Municipal Building 625 52nd Street – Room 202	<i>Kenosha City Plan Commission</i> <i>Agenda</i>	Thursday, August 8, 2013 5:00 p.m.
<p style="text-align: center;"><i>Mayor Keith Bosman - Chairman, Alderman Kevin Mathewson - Vice-Chairman</i> <i>Alderman Anthony Kennedy, Alderman Jan Michalski,</i> <i>Kathryn Comstock, Anita Faraone, Robert Hayden, Anderson Lattimore, Jessica Olson and Ron Stevens</i></p>

CITY PLAN COMMISSION
Minutes
JULY 18, 2013

Planning & Zoning Division 625 52nd Street - Room 308 Kenosha, WI 53140 262.653.4030	Kenosha City Plan Commission FACT SHEET	August 8, 2013	Item 1 Page 1
Conditional Use Permit for a Recycling Collection Center to be located at 6000 49th Street. (Kenosha Recycling, Inc.) (District #16) PUBLIC HEARING

DATE: July 1, 2013
SUBJECT: PLAN REVIEW COMMENTS
Project Description: Kenosha Recycling Inc.
Location: 6000 49th Street

Traffic Comments:

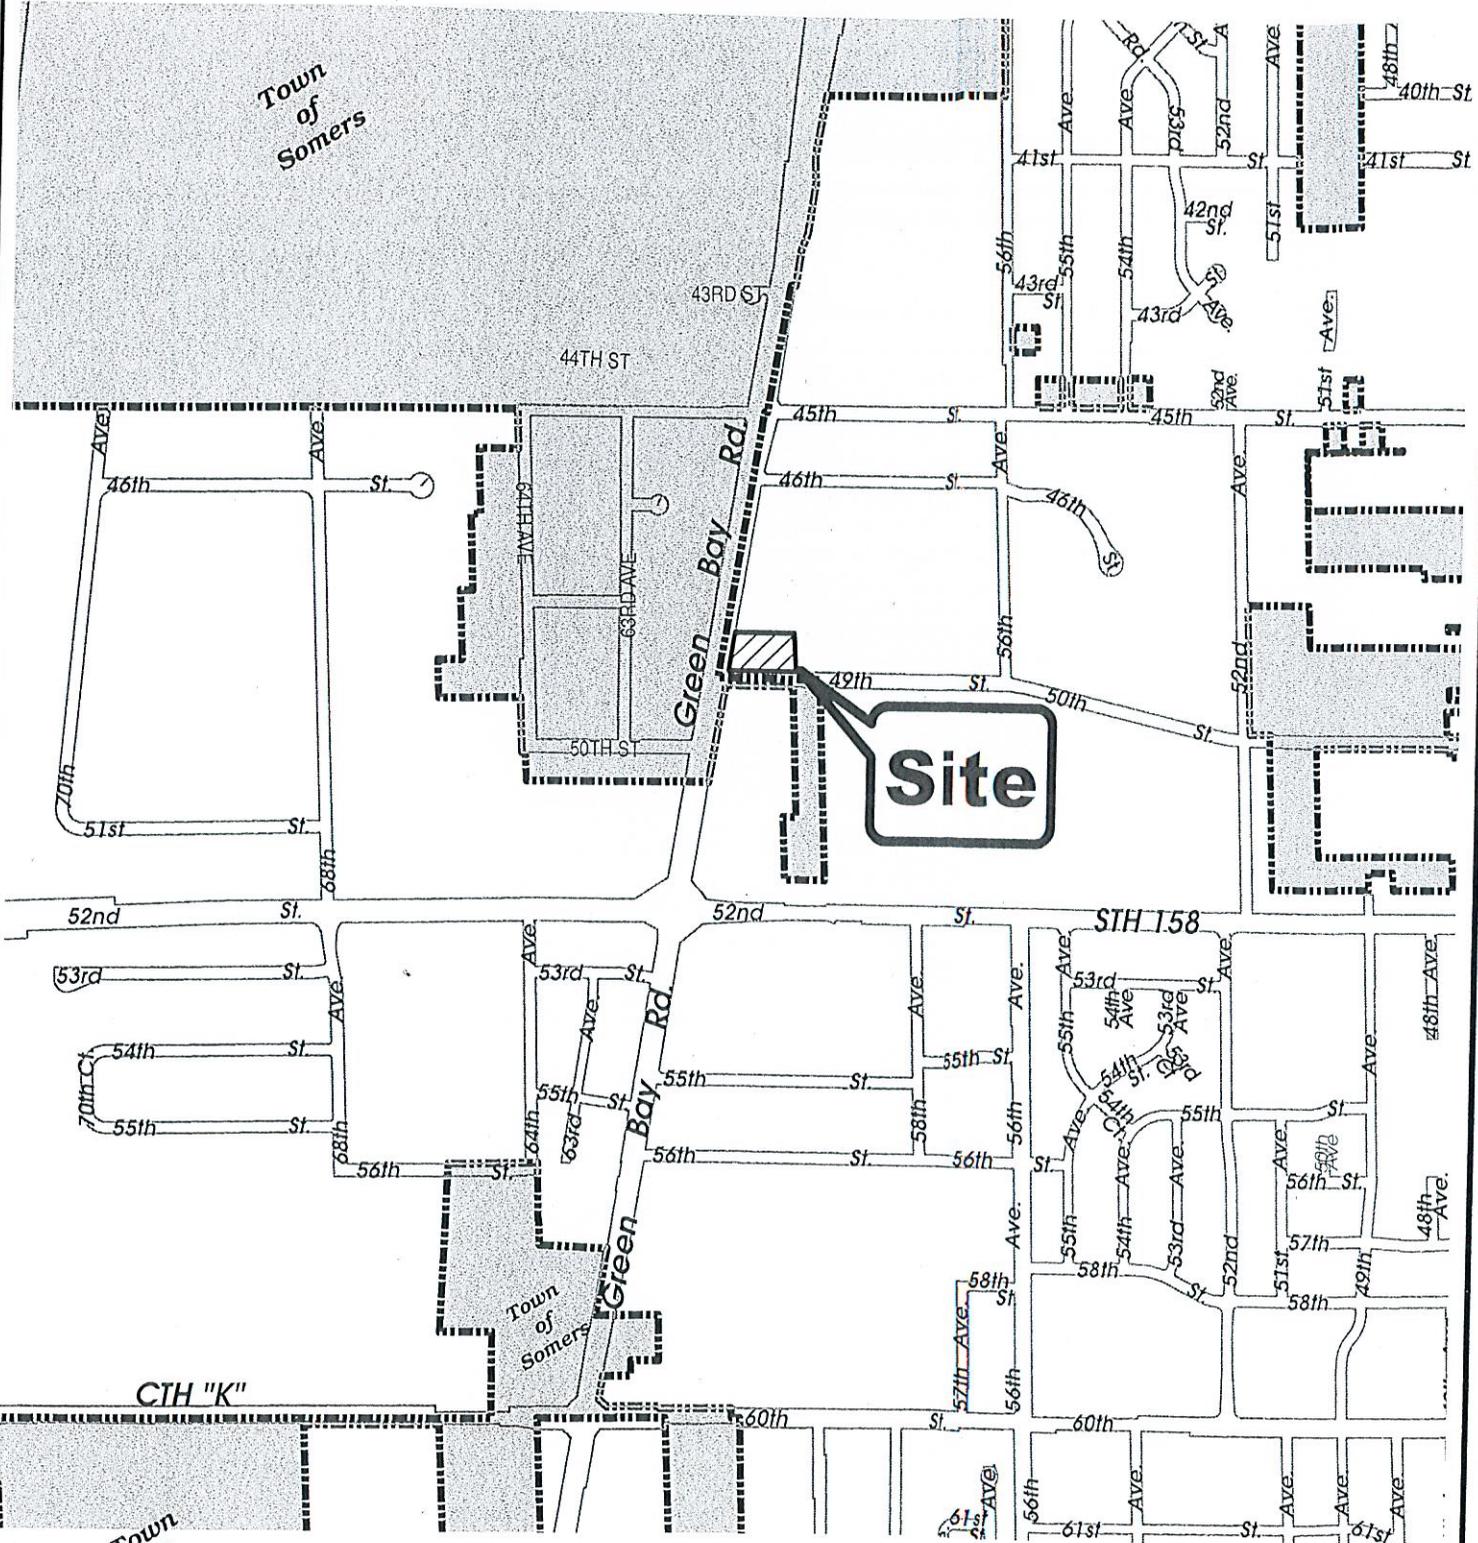
- Existing and proposed site plans are required to adequately review the site. Plans should show the existing and proposed pervious areas and the proposed area of disturbance so it can be determined if post-construction stormwater management facilities will be required.
- Further comments will be given when a full set of plans are reviewed.

- Provide plans of the facility drawn to 1:20 scale.
- Plan shall show all property lines, existing and proposed structures.

3. Provide parking stall layout and annotate direction of traffic.
4. Show sidewalk on the plan and indicate the dimensions of the driveways on the plan.
5. Provide a lighting plan.
6. Type of permit required will be determined when a complete set of plans is provided.

MEDIUM40-Ni
SITE DEMOLITION PLAN

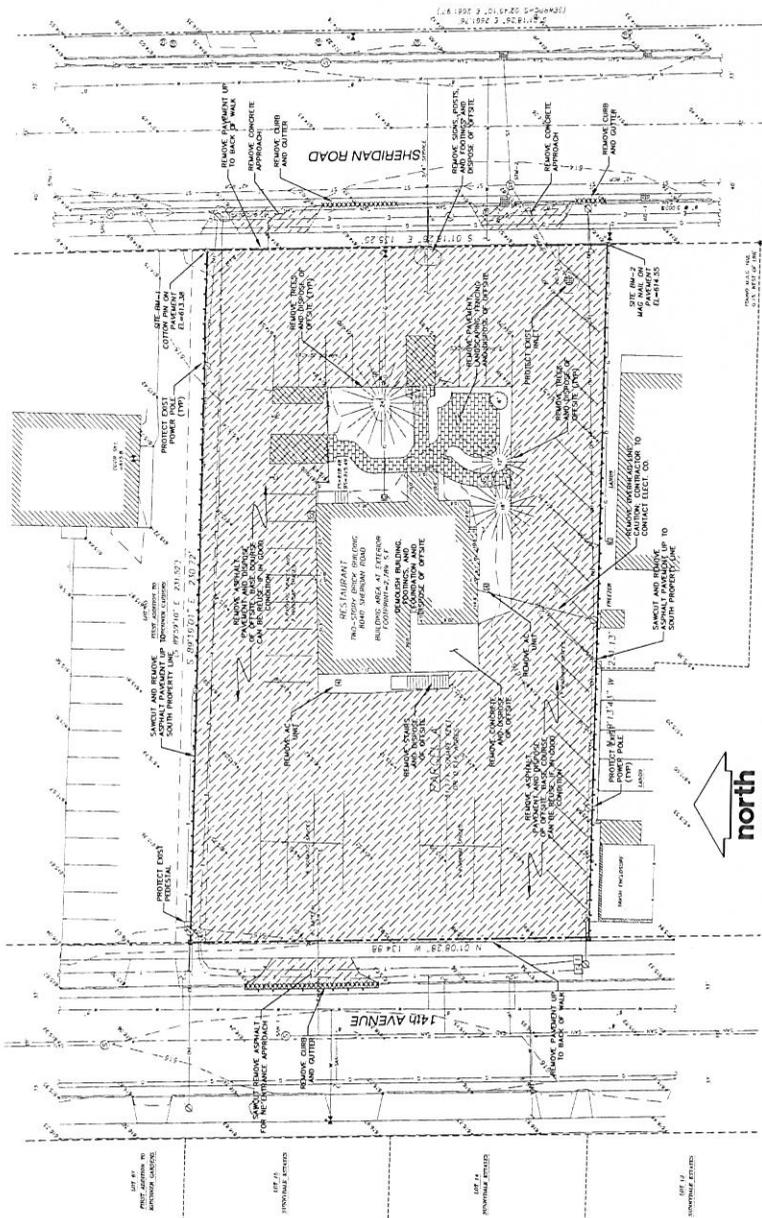
1. The Demolition Plan (Sheet C-1.0) shall include a note to cut and cap the existing sanitary sewer lateral along the west property line. The plan shall also include a note to cut or peen off the water service being abandoned along the east property line.

MEDIUM 40-NI
 SITE UTILITY PLAN

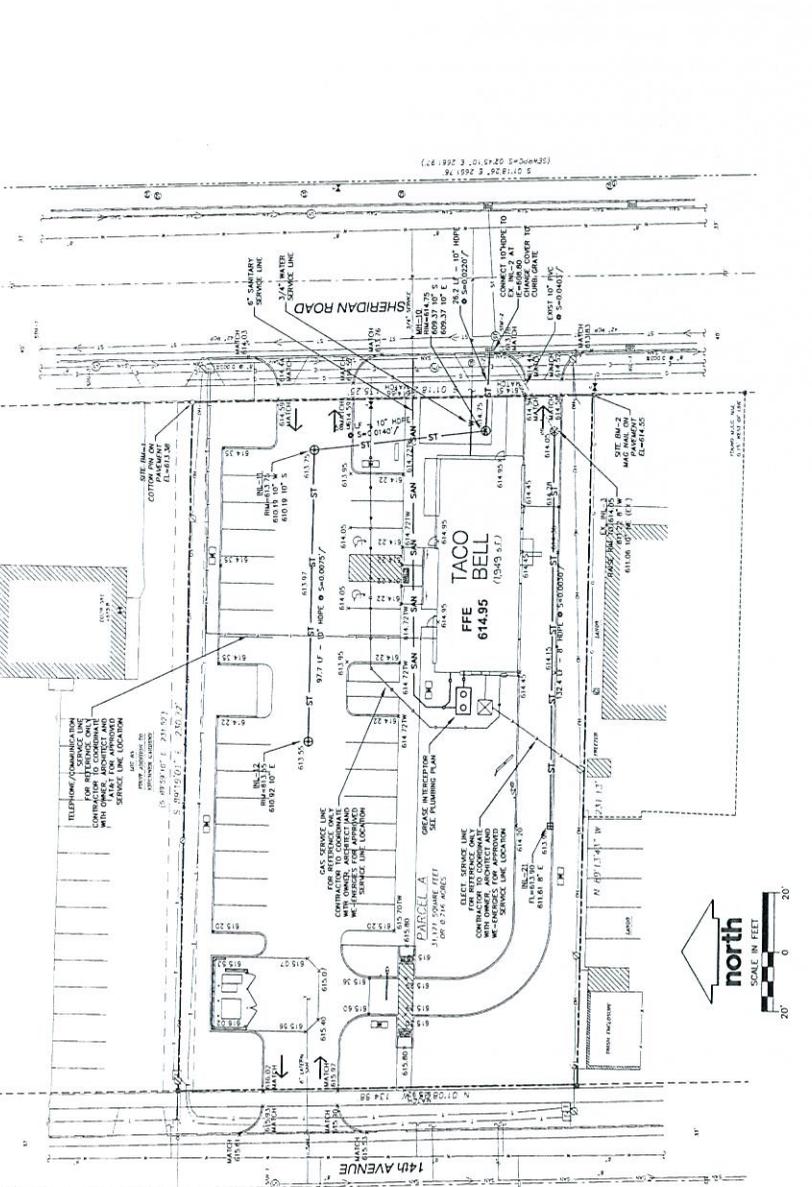
7. The first part of Note 9 on the Utility Plan makes reference to a 4" polyvinyl chloride water service but the plans show a 3/4" service. As mentioned earlier, the architect noted that a one and one half inch (1-1/2") service will be required and the plan shall

be updated to reflect this change. Also, the reference to the Village of Pewaukee in this note shall be replaced with "Kenosha Water Utility".

8. The third part of Note 9 on the Utility Plan shall be changed to read as follows:
Water services shall have a blue 12 gauge locator wire installed along the entire length. Locator wire shall be brought to the surface in the curb box and at the edge of the building and enclosed in a curb box with "water" on the cover.
